## **ADDENDUM No. FOUR**

Project Name: Lemur Lookout Exhibit  
Brandywine Zoo

Project No.: WBZ-7

Date of Issue: Friday, October 11, 2019

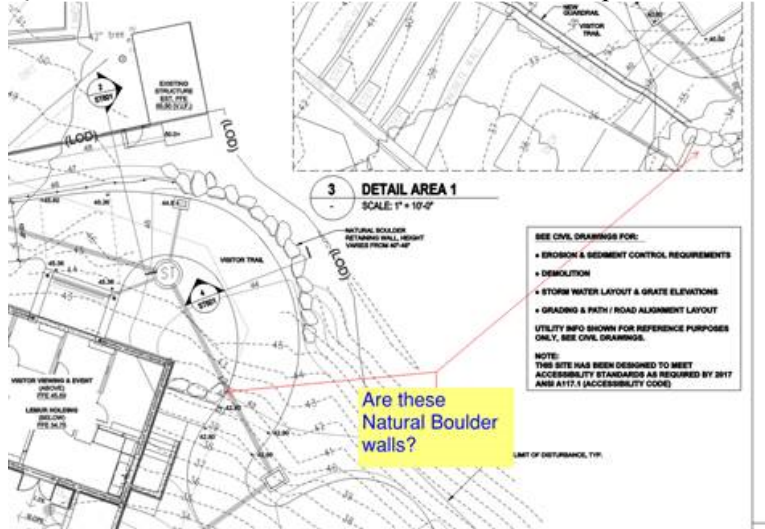
- 14 Question: The drawings do not provide a temporary barricade plan or temporary directional signage to be placed during construction. Please clarify barricade/signage type and location if this is to be provided by the GC.

Response: The temporary barricade will need to be coordinated with the owner to accommodate the work to the USDA fence as well as maintain other zoo operations. A USDA fence similar to Detail 8, Sheet ST703 shall be provided to separate the construction zone from the occupied Zoo. Fence posts can set 3-feet in grade in lieu of concrete. Fence location will need to be adjusted as necessary to accommodate construction phases.
